TWISTER

FIELD INSPECTION POINTS

SERVICE BULLETIN

Ride: TWISTER

Subject: INSTALLATION OF RESTRAINING BELTS

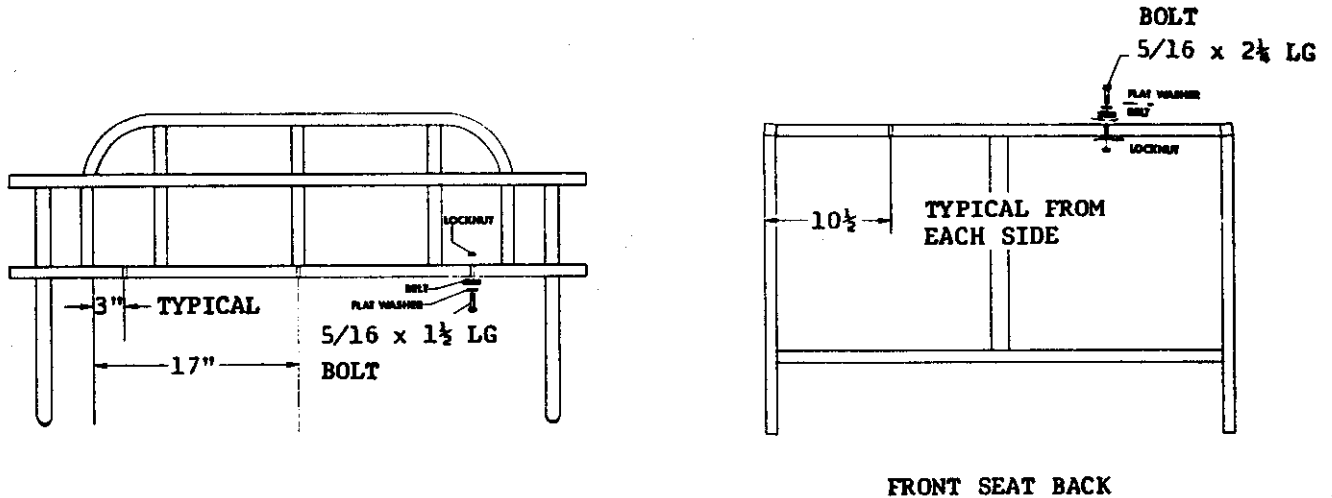
This Service Bulletin is to inform you as a TWISTER owner of a condition that makes the addition of restraining belts to your TWISTER cars necessary and desirable. A complete set of these restraining belts will be shipped to you immediately upon return to us of the enclosed card.

These restraining belts are to be installed in all your TWISTER cars immediately upon receipt.

1. Remove the headrests from the cars and drill three 5/16" diameter holes in each one as shown.
2. Install 5/16 x 1½ LG bolt, flat washer and restraining belt from bottom side of tube on the headrest and secure with locknut.
3. Drill two 5/16" diameter holes down thru the square tube that supports the back of the front seat of each car.
4. Install 5/16 x 2¼ LG bolt, flatwasher and restraining belt from top side of tube and secure with locknut.

When installing belts make sure they are not twisted before bolting.

Subject: Floor lift cylinder-structure addition.

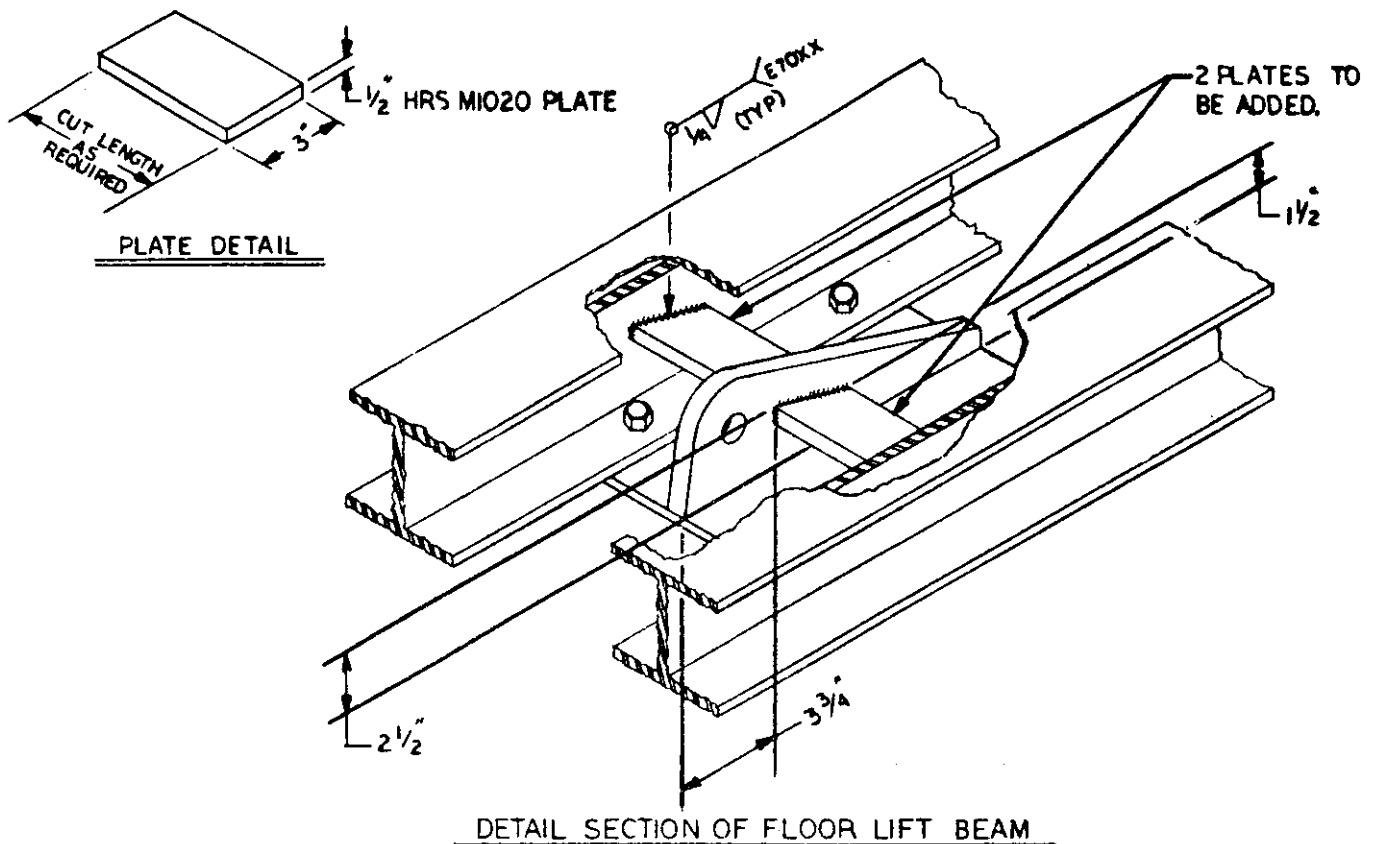
In order to improve the structure of the floor lift beam cylinder mounting bracket, we ask that the following change be added to both floor lift beams. Weld two $\frac{1}{2}$ " steel plates, one to each side of the hydraulic cylinder mount, in accordance with the dimensions shown in the detail section. Ride owner to furnish plates to be added.

Subject: Trailer Reinforcement

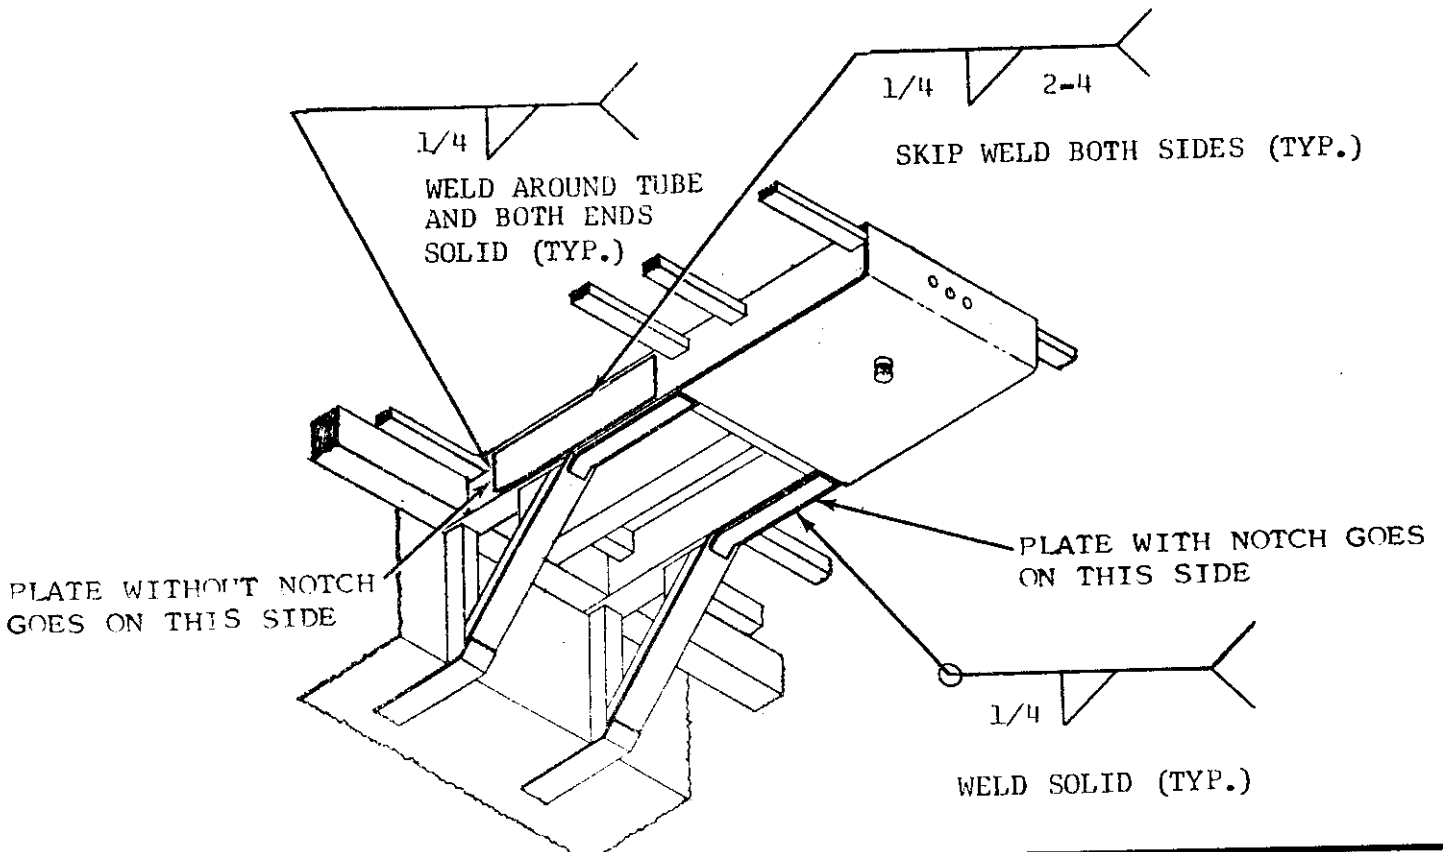
We wish to inform all Twister owners of an area on the Twister trailer that could be termed marginal as far as strength goes. Should the trailer become bogged in mud and you try to jerk it free, it is possible that the main support tubes could bend. This could also happen if the trailer were bouncing severely on a rough highway. Enclosed is a print showing details of some plates. We are recommending that these plates be added to the trailer immediately. The print calls for 3/8" thick plate and this is recommended. However, if the 3/8" plate is not available, 1/4" plate could be substituted.

Subject: INSTALLATION OF CONTROL LEVER DETENT

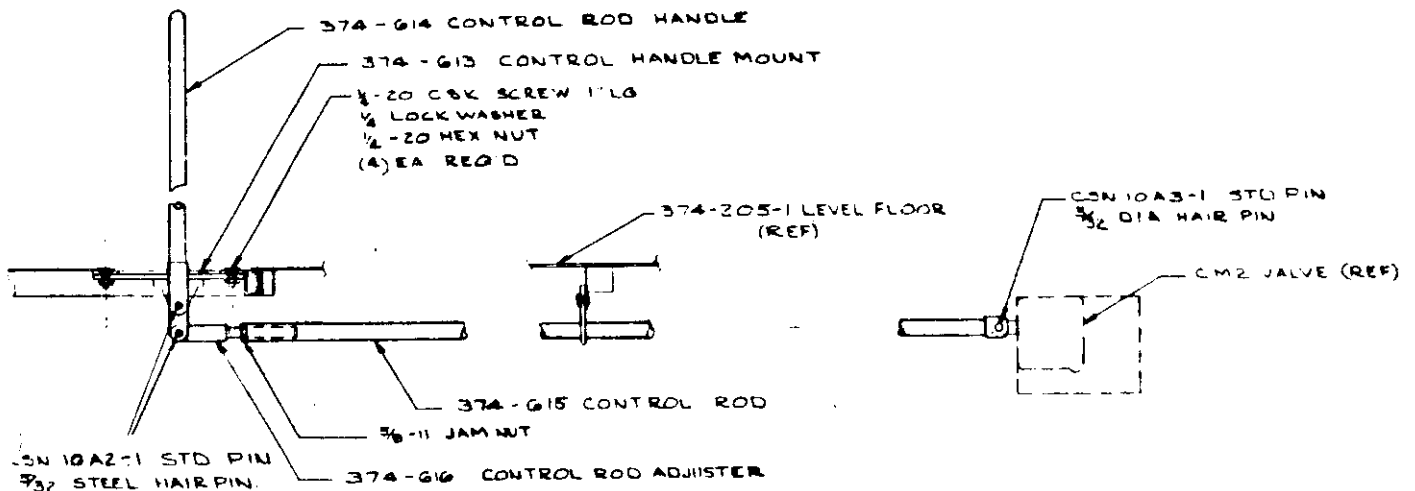
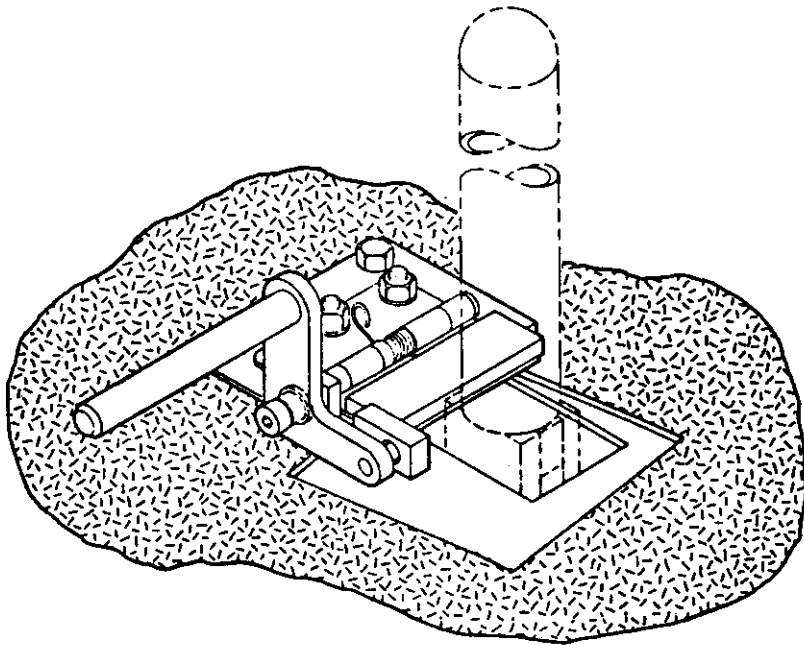
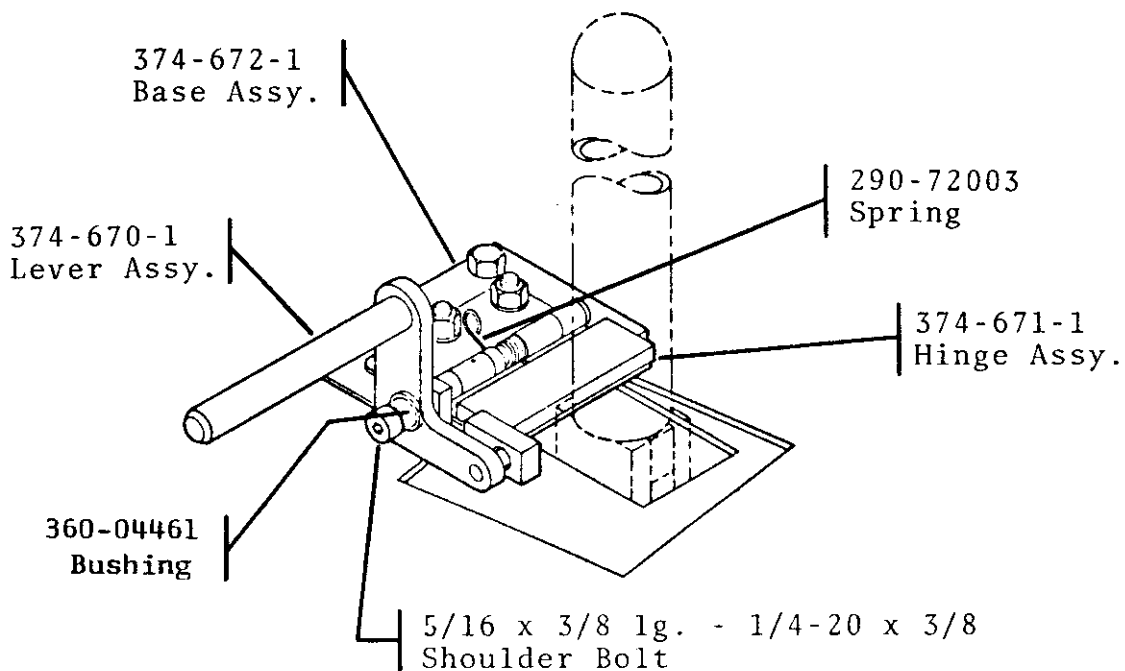
The following instructions cover installation of a Control Lever Detent which is to be added to each TWISTER.

The detent will prevent an accidental engagement of the Control Lever during loading or unloading of the ride.

Before installing the detent, the Control Rod Handle should be adjusted so it is in a vertical position.

To adjust handle, loosen the jam nut and adjuster on the control rod underneath the porch. Turn adjuster until Control Handle is vertical and tighten jam nut.

Position Detent Assembly in front of the Control Handle, centering it with the travel of the Handle.

If there is any slop or play in the travel of the handle, push it forward gently until it is at the point of engaging the control valve.

Now, position the detent so that it is up against the Control Handle.

Mark and drill holes to match Detent Base Plate, securing with bolts provided.

Subject: BRAKE RELIEF VALVE
PRESSURE SETTING

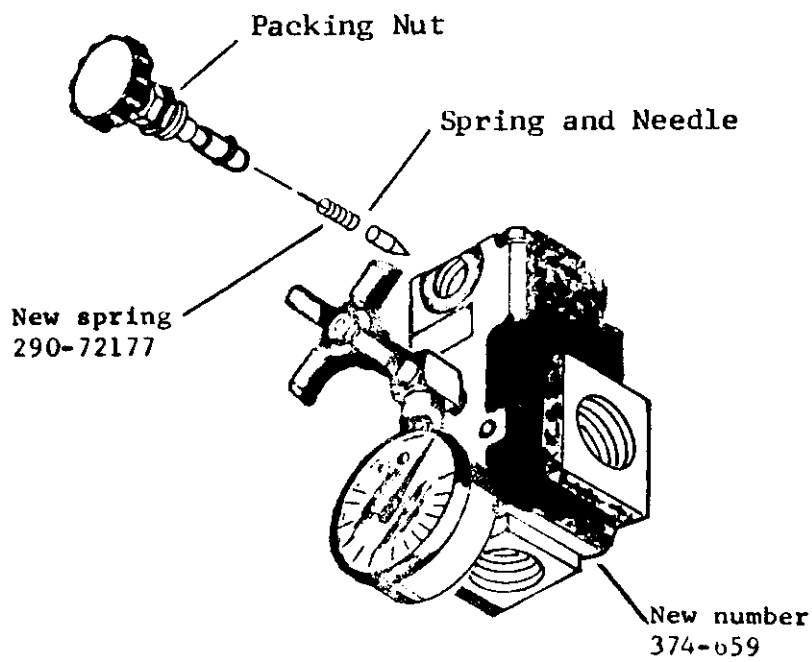
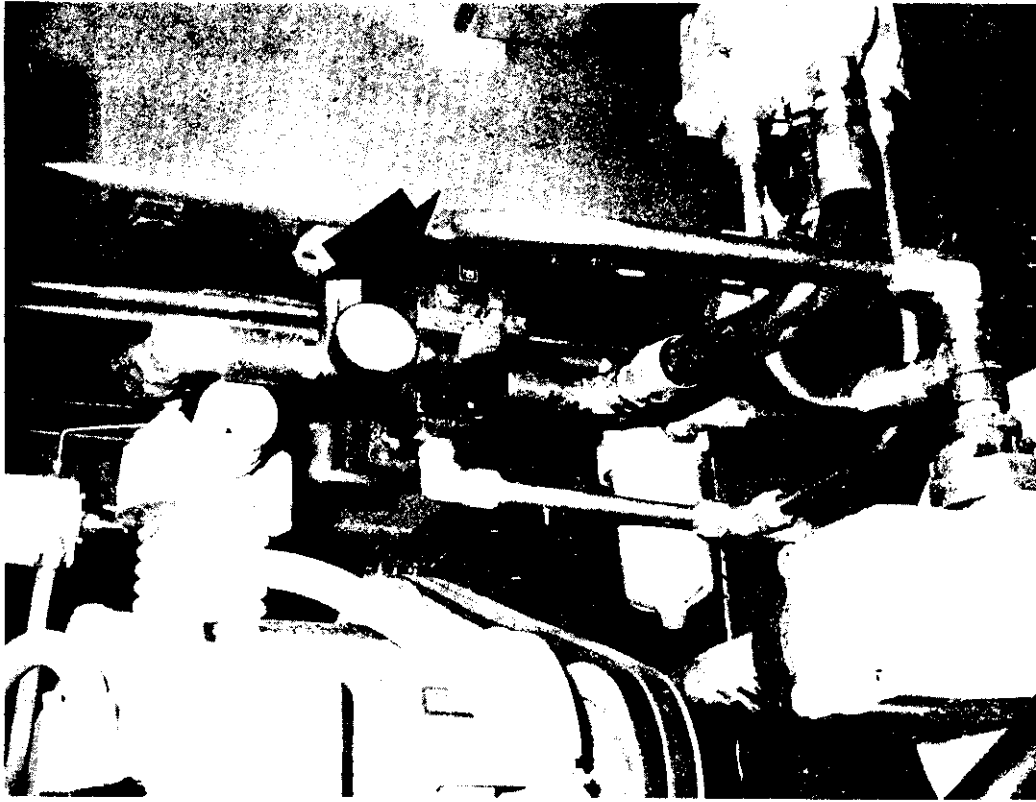
From field observations, it has become apparent that a number of TWISTER Rides are being operated with the "Brake Pressure Relief Valve" set at a higher pressure setting than the recommended 700 P.S.I. maximum.

This results in a severe braking action causing discomfort to ride passengers. In addition, it subjects the ride structure to undue stresses.

To eliminate this, we have enclosed a new spring that is to be installed in the relief valve. This will limit the valve to a maximum setting of approximately 700 P.S.I.

To replace spring, loosen the packing nut behind the Adjustment Knob, and carefully remove Adjustment Knob and Stem.

Replace spring and assemble in reverse order.

Run the ride and adjust Relief Valve to approximately 600-700 P.S.I.

Subject: CHECKING SWEEP FOR CRACKS

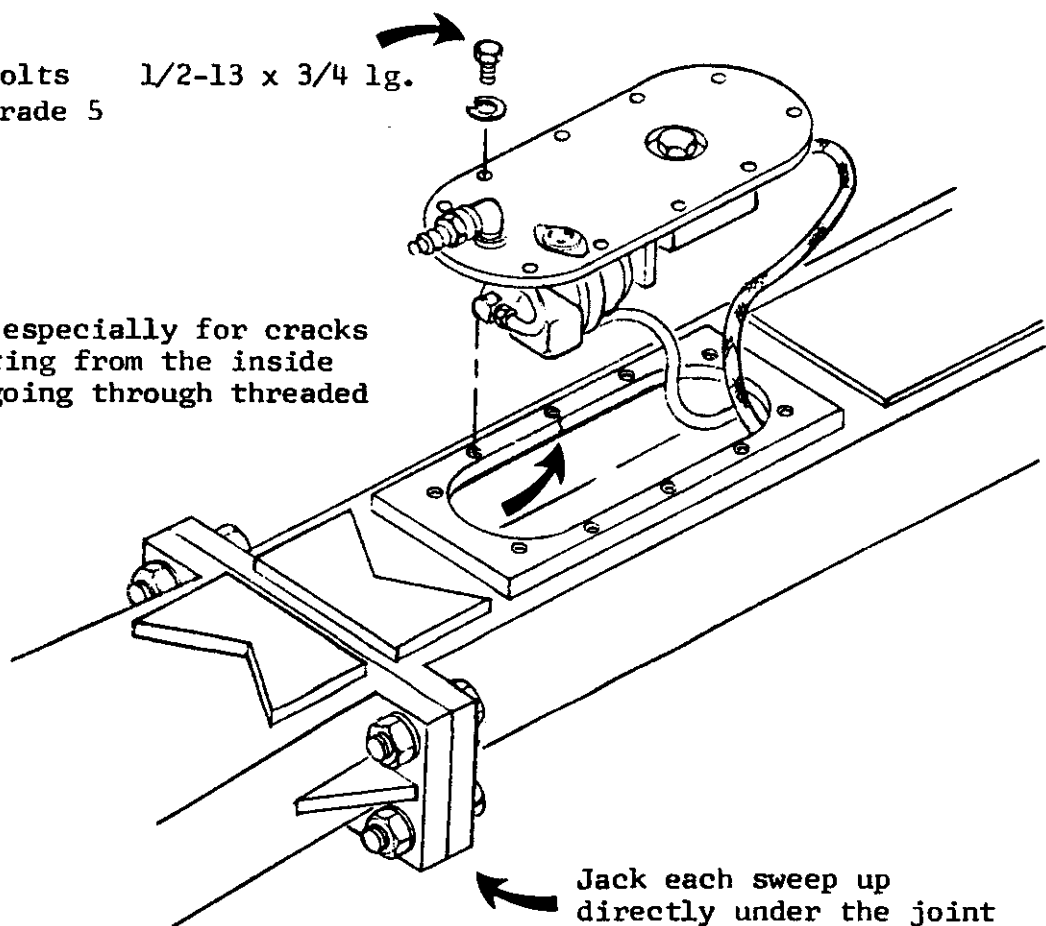
One of the Outer Sweeps on a TWISTER has developed a crack in it. The crack developed across the top side starting from the access hole for the Master Cylinder. This has only shown up on one sweep and could be attributed to any one of several possible causes.

However, the most logical cause for the crack is simply that the cover plate was not bolted down tightly.

The cover plate, when tightened down, adds the necessary strength needed in this area of the sweep because of the access hole.

Remove the cover plate * and inspect area around access hole.

After preliminary check, block or jack each sweep up directly under the bolted joint for inner and outer sweep sections.

Again visually inspect area around access hole while having partner stand on the car and bounce. This will possibly cause crack to show up enough to visually sight if one exists.

Look especially for cracks starting from the inside and going through threaded hole.

If no cracks are found, install cover plates, torquing bolts to 75 ft. lbs. If bolts are greasy or oily, torque to 55 ft. lbs.

Check length of bolts before installing cover plates. The six bolts along sides should be 3/4 inch long grade 5 bolts. Longer bolts will bottom out against the sweep channel not drawing the cover plate down tight.

Subject: Sweep Check

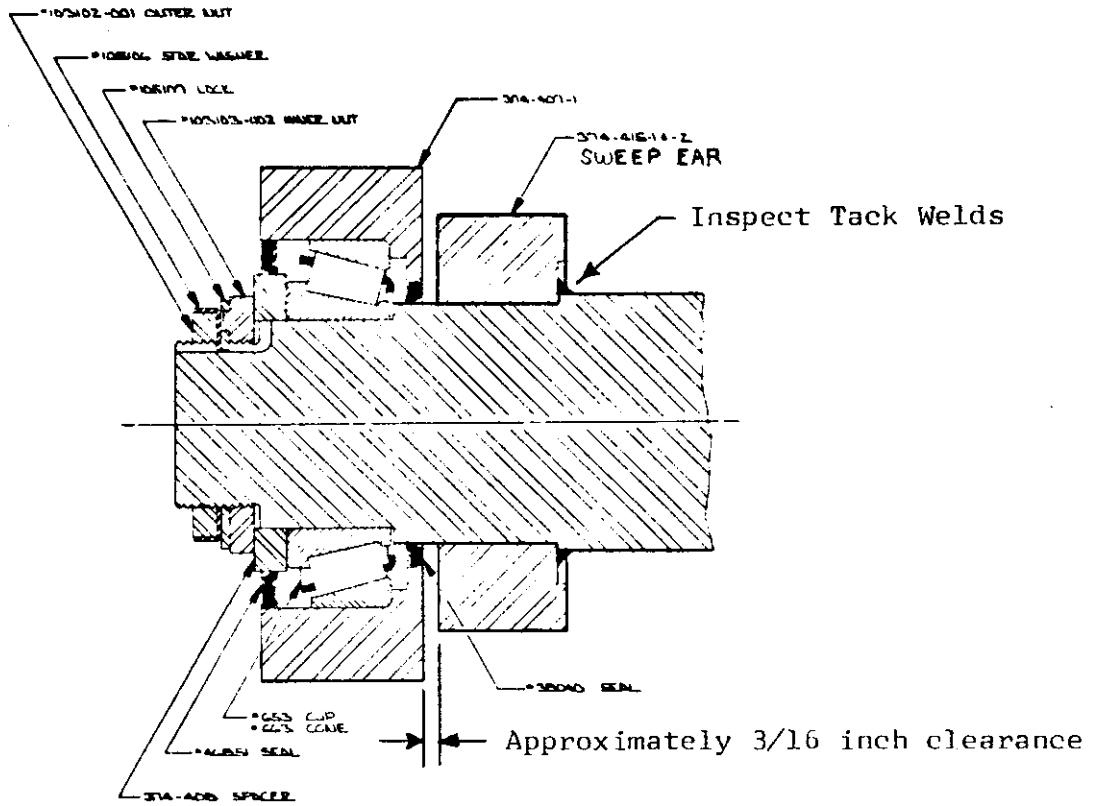
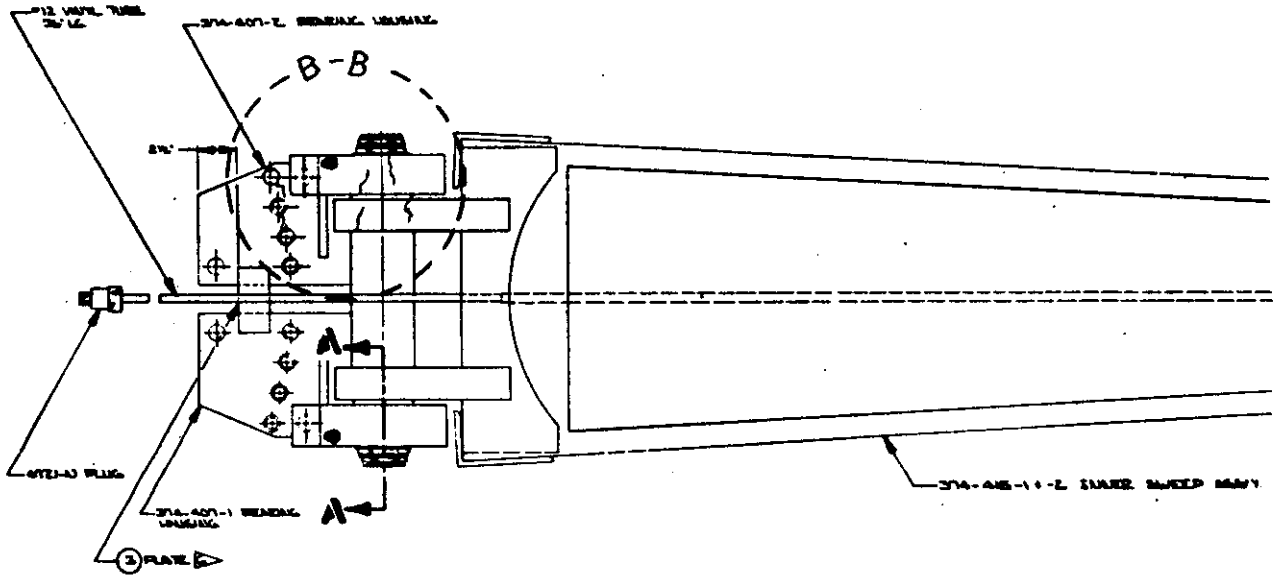
One ride has reportedly developed some problems with the sweep joints where they attach to the center hub. In order to evaluate the precise area and cause, more information is needed from the field.

1. Inspect the plate and ears that bolt onto the Center Hub, paying particular attention to the area around the bolt holes. "B-B" and ears that house the Bearings shown in section "A-A".

2. The sweep shaft is tack welded to the sweep ears as shown in "A-A". Inspect this area very carefully to see if welds are holding.

Also, check clearance between sweep ear and the bearing ear. There should be approximately 3/16 inch between the ears.

3. Have two men rock the outer sweep end and observe the hub end of the sweep for any signs of play in the bearings, etc.

4. In addition to checking the sweep, make sure the Braking Pressure is limited to approximately 600 PSI as prescribed in Bulletin #90, 11-8-74. As stated in that bulletin, higher pressures subject the entire ride to undue stress forces during the braking cycles.

Subject: SWEEP REPORT

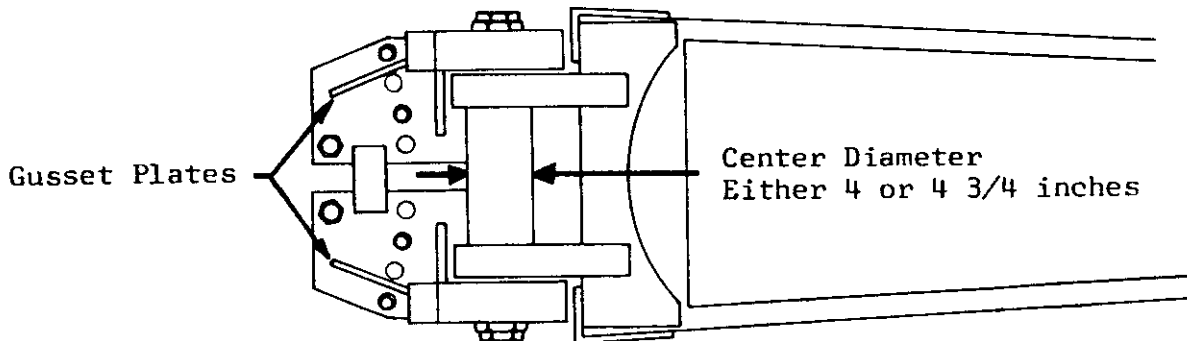
After evaluating the reports on the Sweep joints, Ref. Bulletin 104, it has been determined that it would be desirable to reinforce all existing sweep joints, that haven't already been done.

1. Center diameter of shaft.
2. Bearing housing (does or does not) have gusset plates as shown.
